Updated Scope for Project Proposal: SFF-TA-1016

Updated Scope Presented: September 27, 2024

Project Proposal: SFF-TA-1016, new updates to Rev 1.2

NEW: Pages 59 & 60, Remove EDSFF LP vertical connector

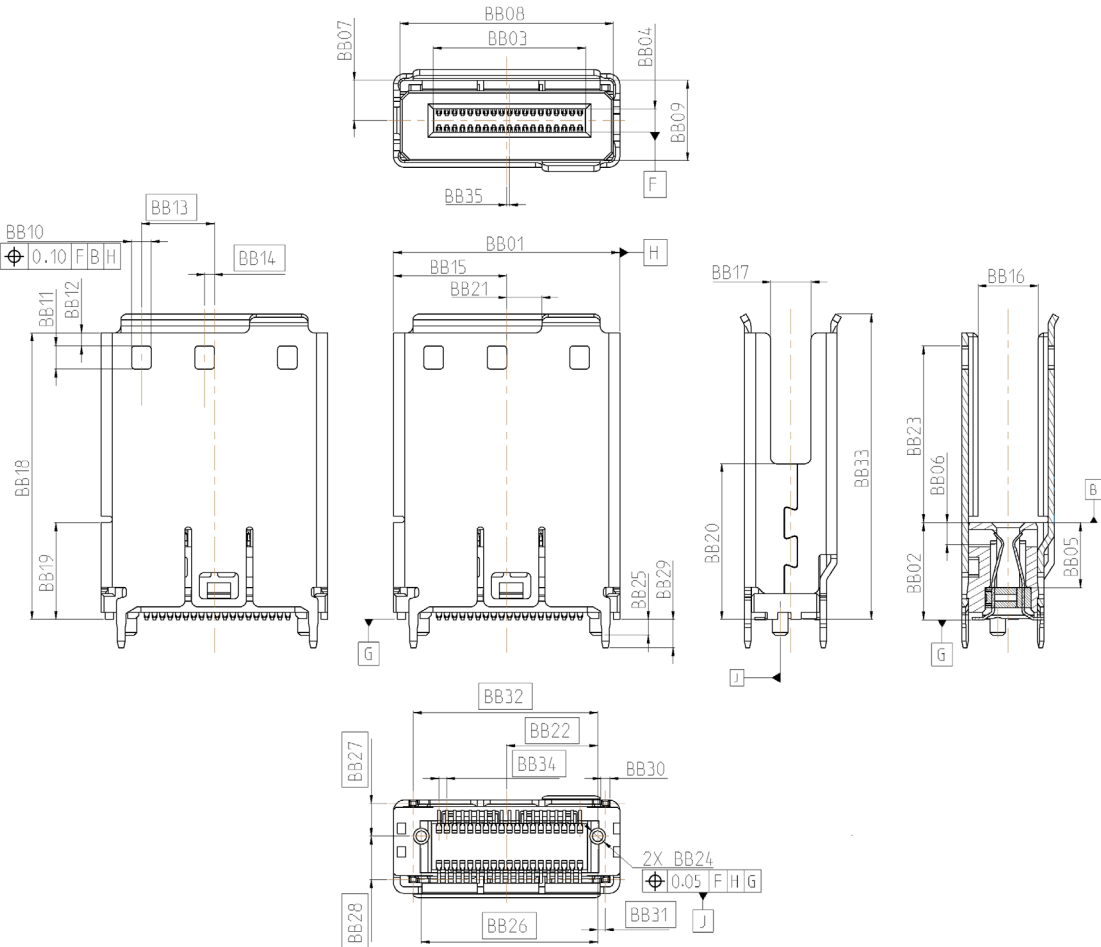
N/A

Figure A-5 Recommended Footprint for Hybrid EDSFF E1/E3 Vertical 38P Connectors

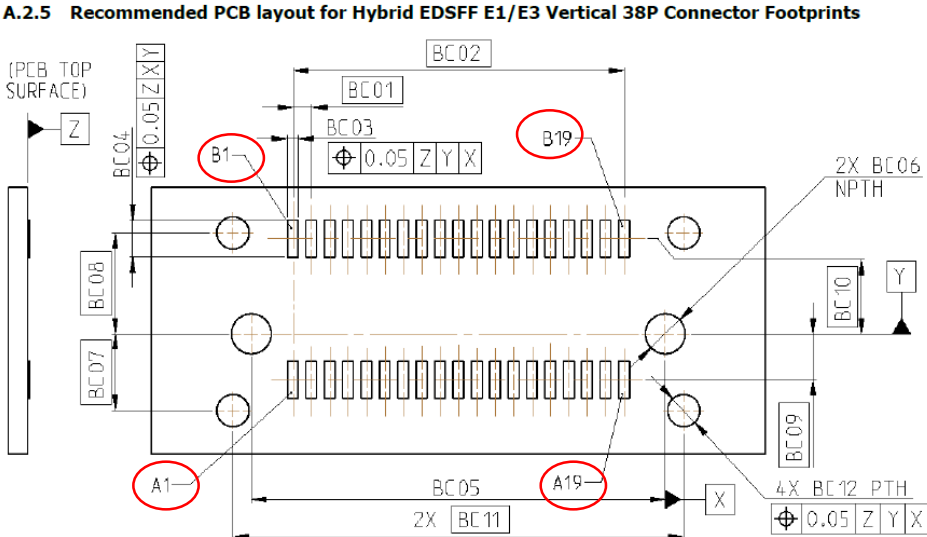
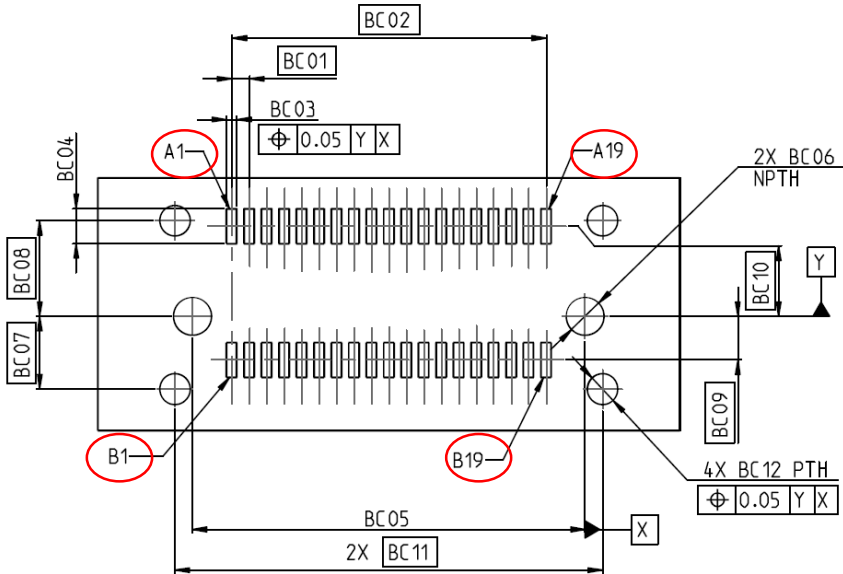
Page. 77 corrected pin A/B row
